DOCUMENT 00 9113 – ADDENDUM #2

A. Project Name: **Sandoval County Sheriff & Emergency Operation Center**
B. Owner Project Number: **FY22-SCPW-05**
C. Owner: **Sandoval County**
D. Architect: **RMKM Architecture, P.C.**
E. RMKM Architect Project Number: **1904**
F. Date of Addendum: **11 February 2022**

A1
LP131
ELECTRICAL ROOF PLAN
1/8" = 1'-0"

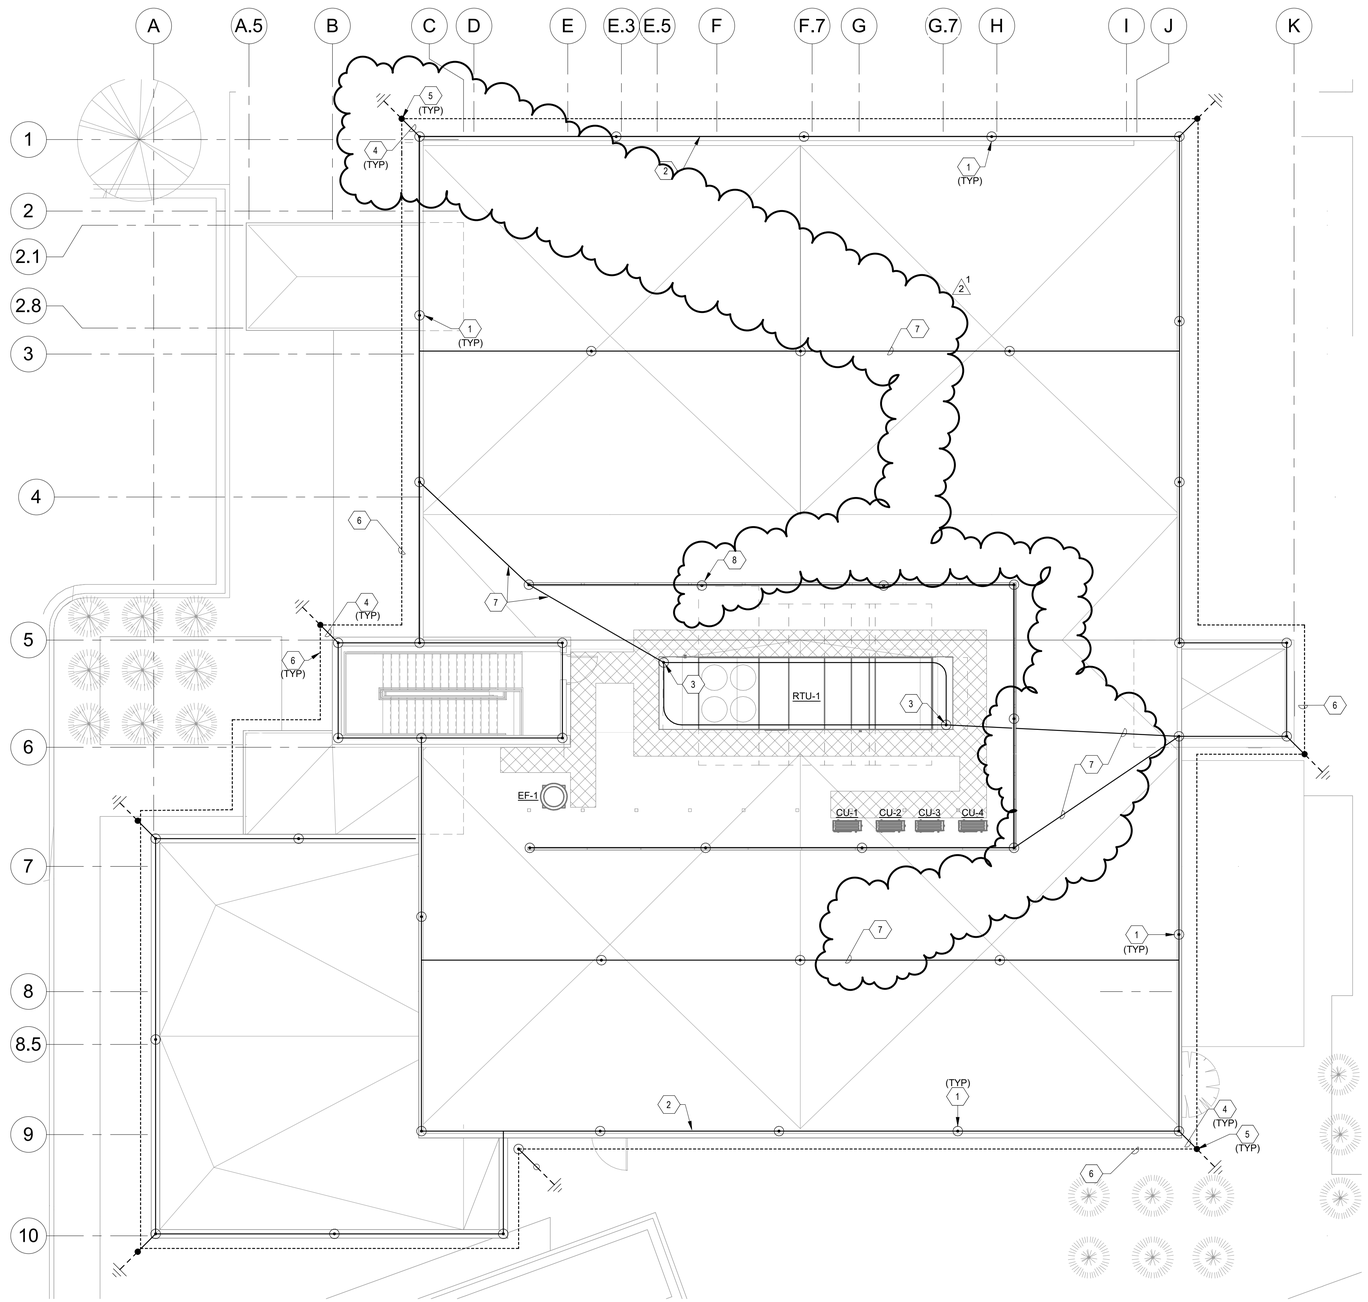
G. LP131
1. Adjusted keyed notes 3 to 8.

A1
FA101

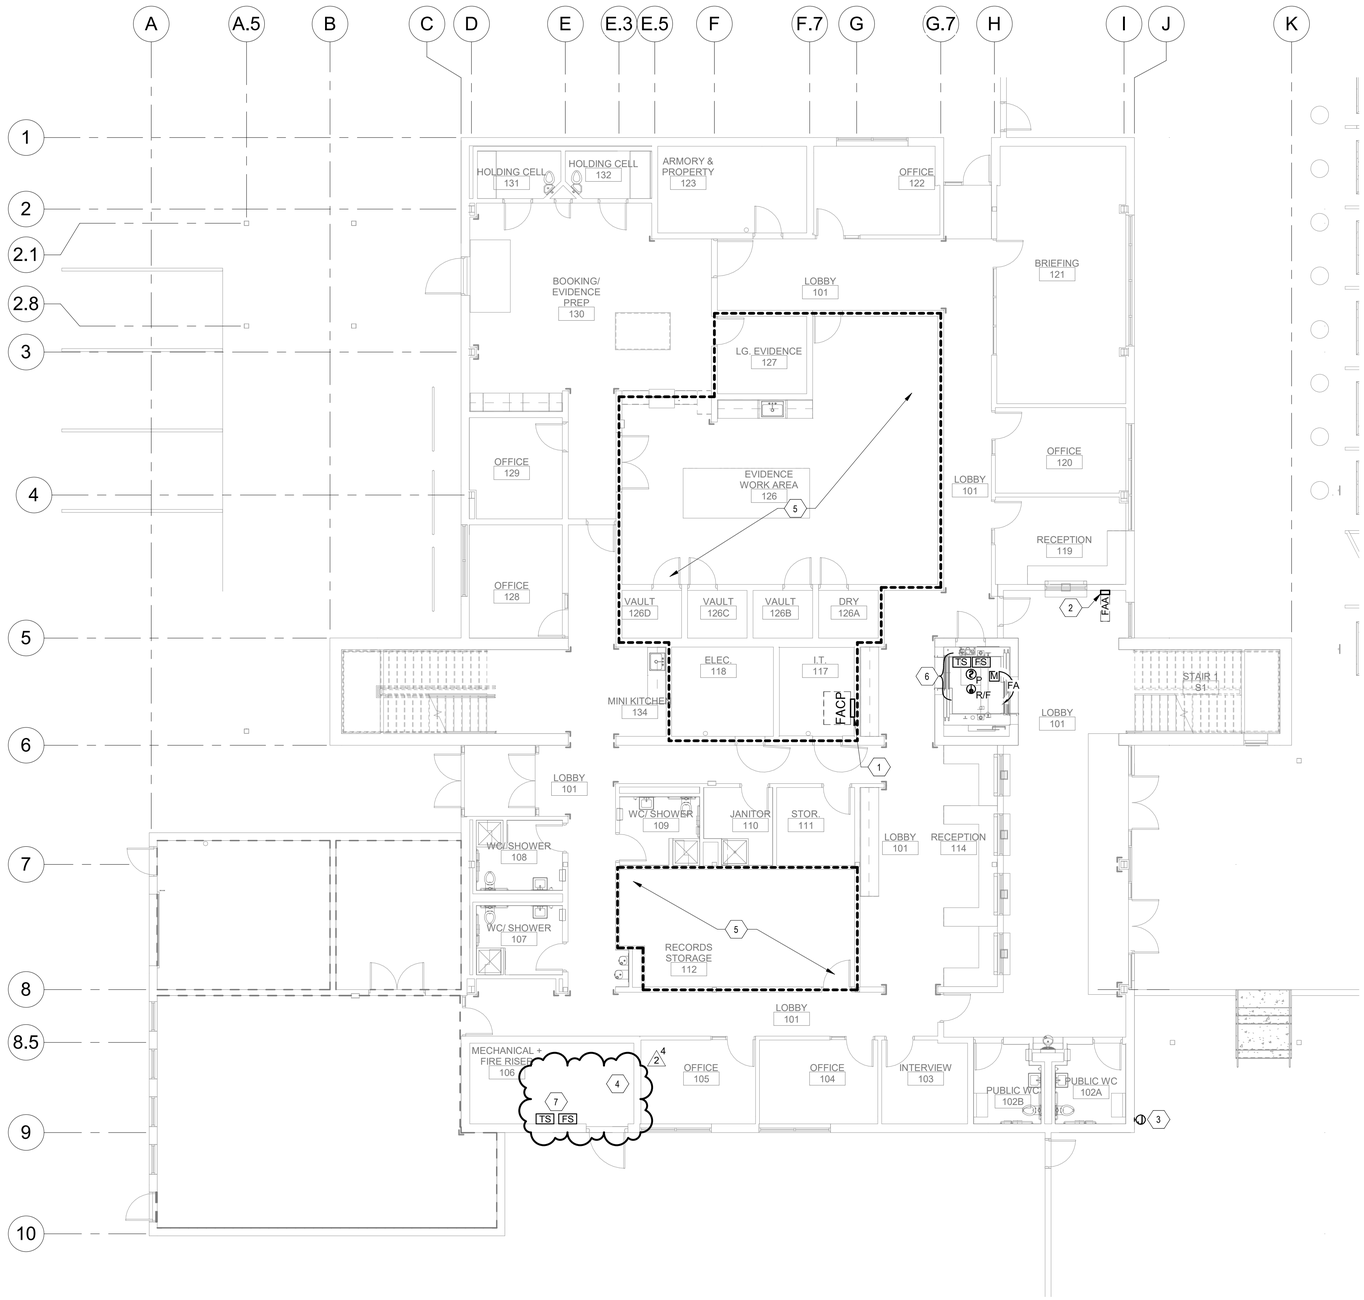
H. FA101
1. Adjusted notes on this sheet.

A1
FA102
FIRE ALARM LEVEL 02 FLOOR PLAN
1/8" = 1'-0"

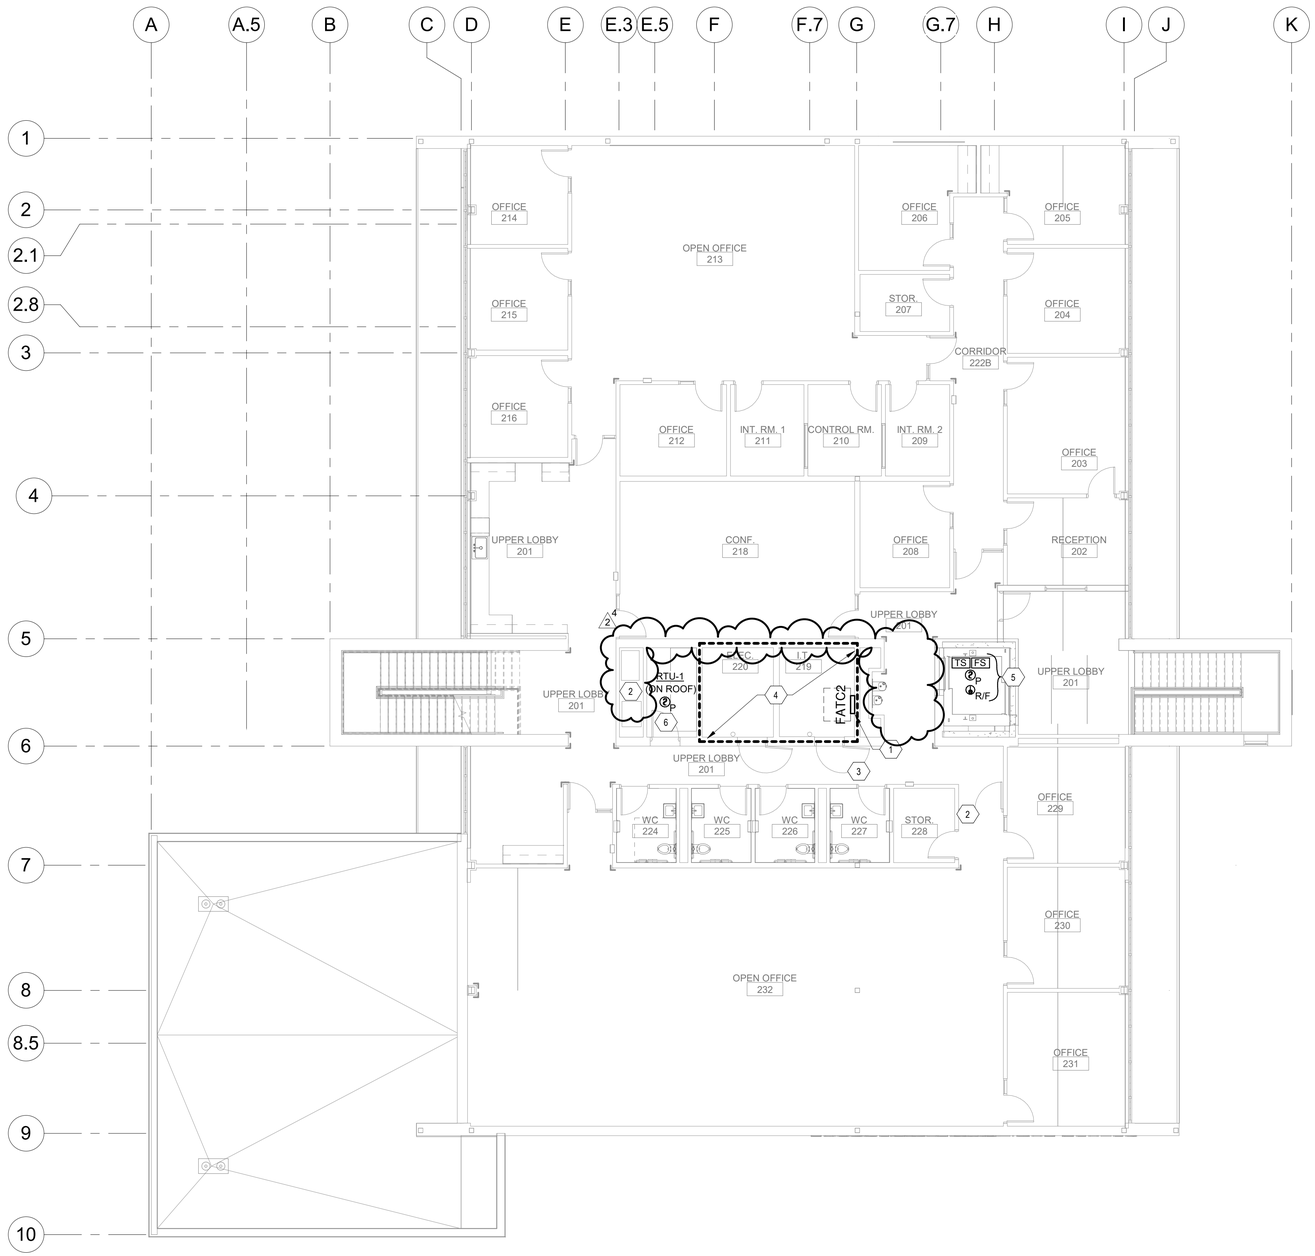
I. FA102
1. Adjusted notes on this sheet.

6 / E-501 POLE BASE DETAIL

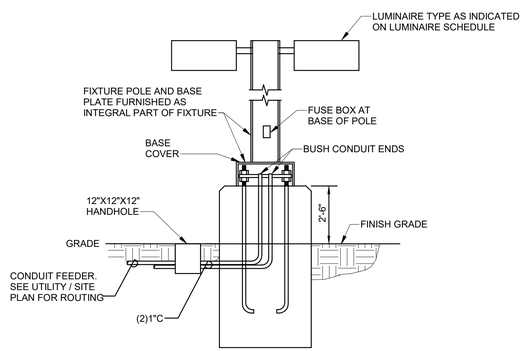
J. E-501
1. Adjusted notes to detail 2 and 6.

1 / E-502 TYPICAL DOWNLEAD DETAIL
NO SCALE

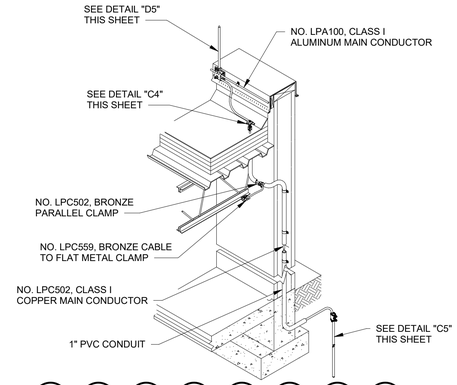
K. E-502
1. Adjusted note in box.
2. Adjusted note in detail1.

4 / E-601 ELECTRICAL ONE-LINE DIAGRAM

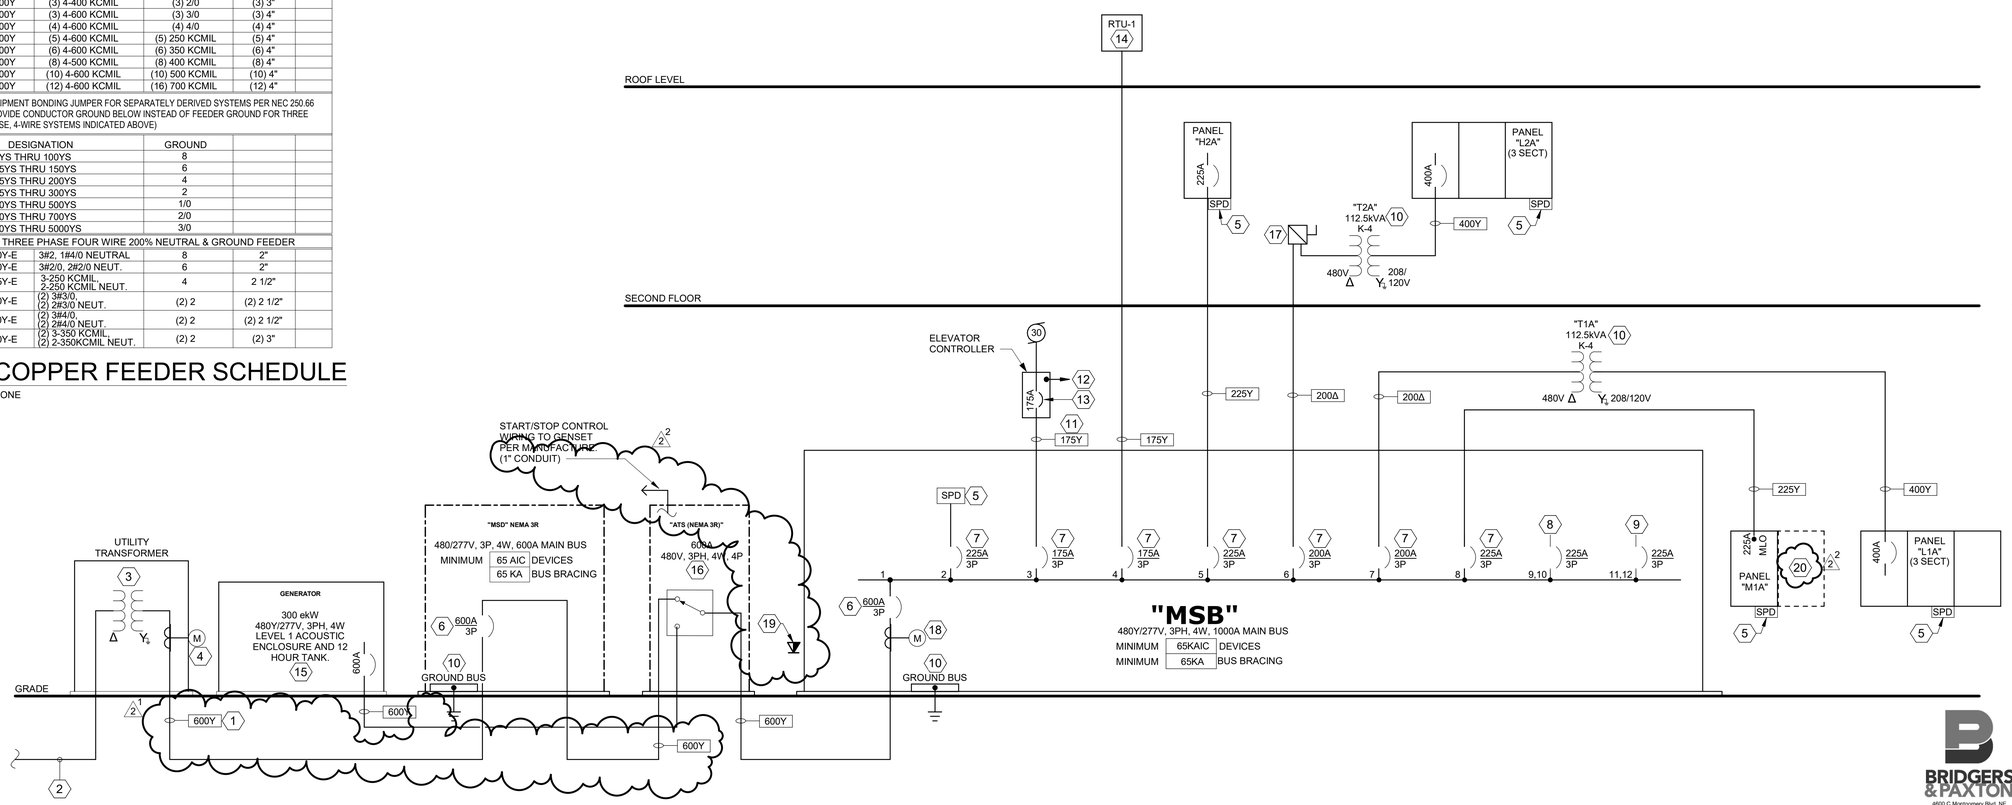
L. E-601
1. Adjusted notes on detail 3.
2. Added data to MSB and added note
3. Adjusted notes at ATS
4. Adjusted feeder tags for incoming secondary.

1 E-602 GROUNDING DIAGRAM
N.T.S.

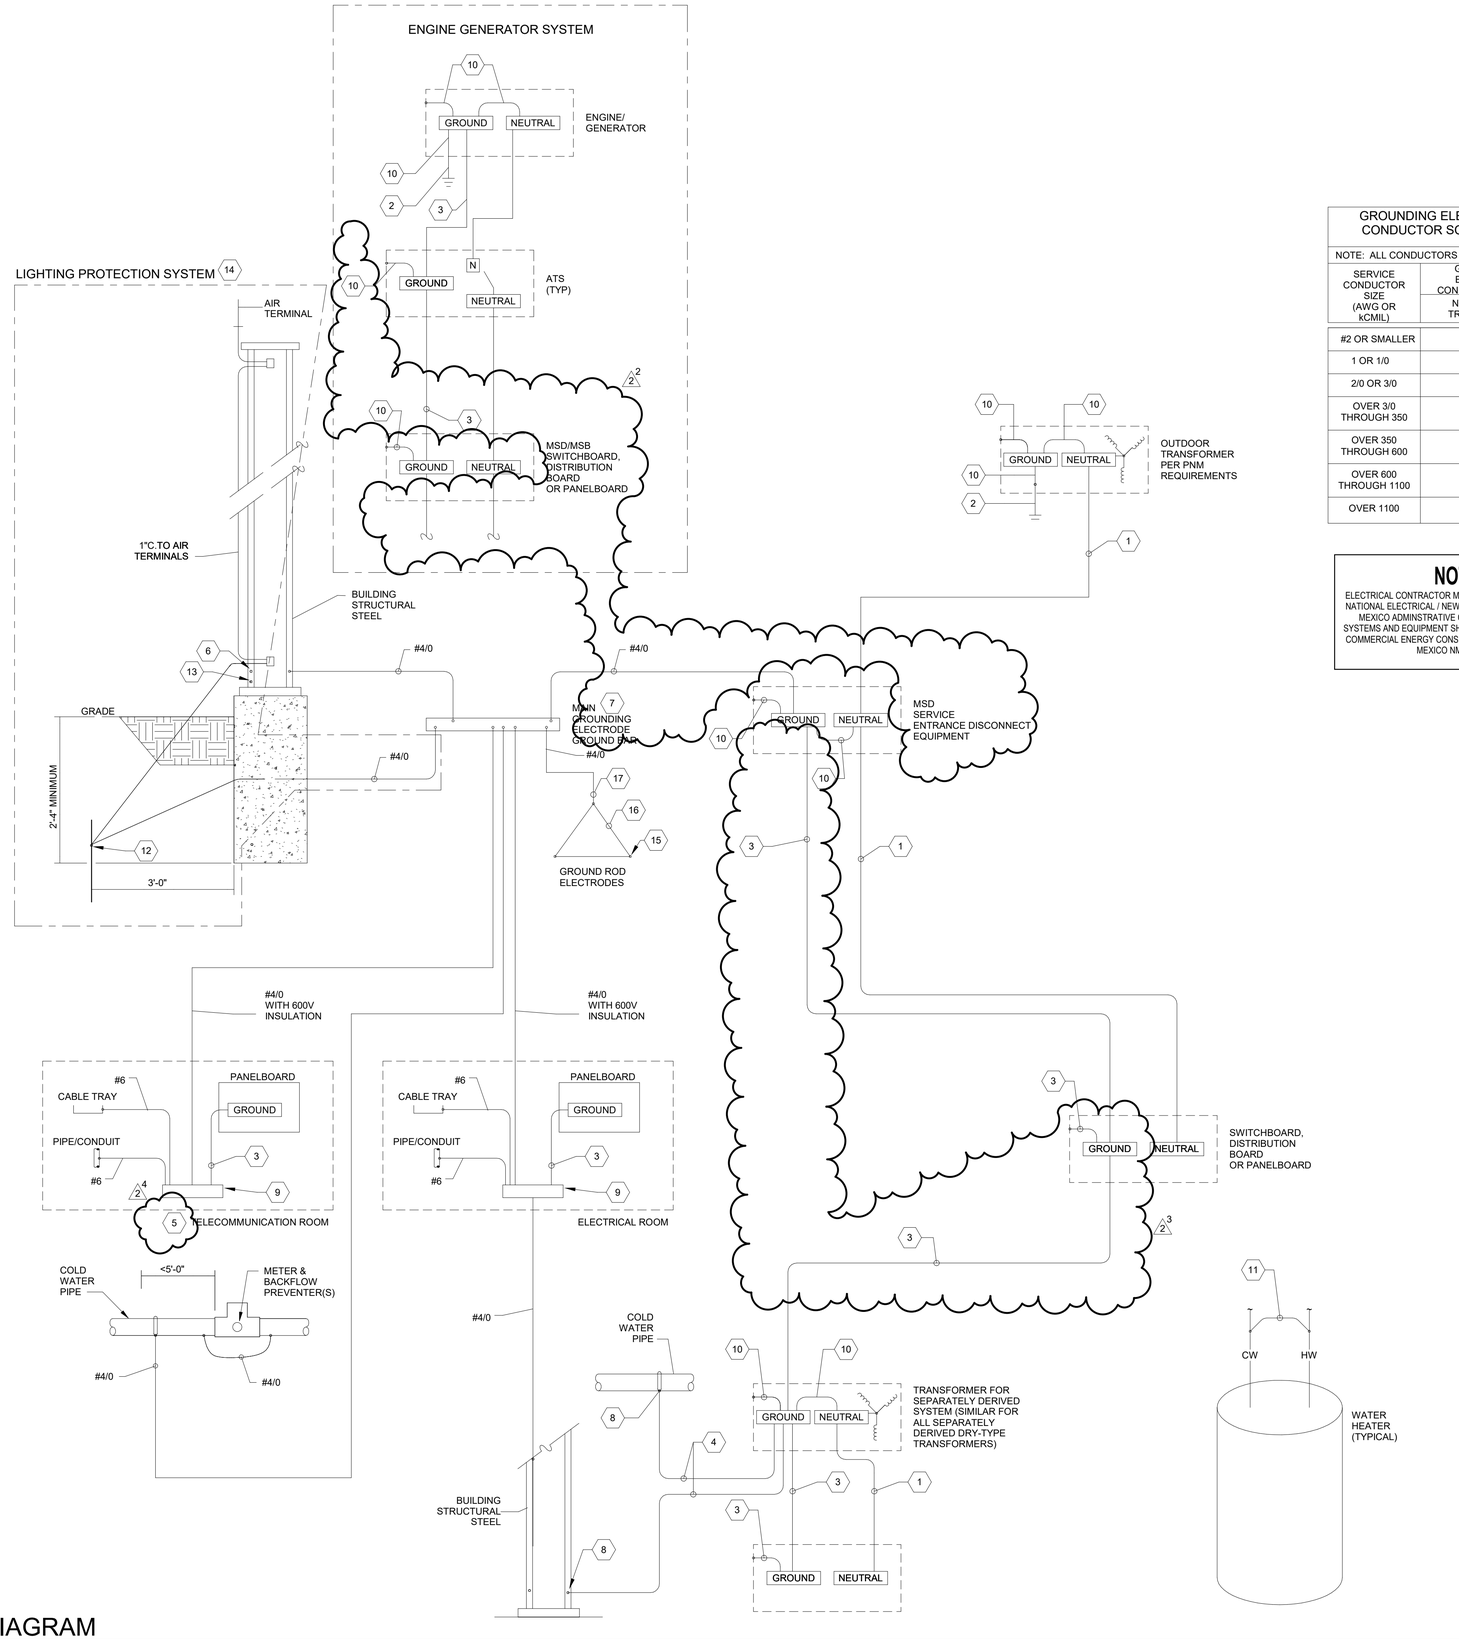
M. E-602
1. Adjusted noting and diagram information.

1 E-603 FIRE ALARM RISER DIAGRAM

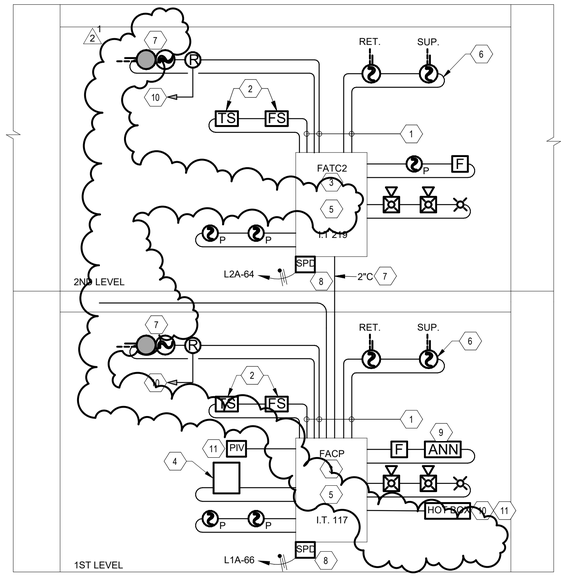
N. E-603
1. Adjusted diagram, notes and box note.
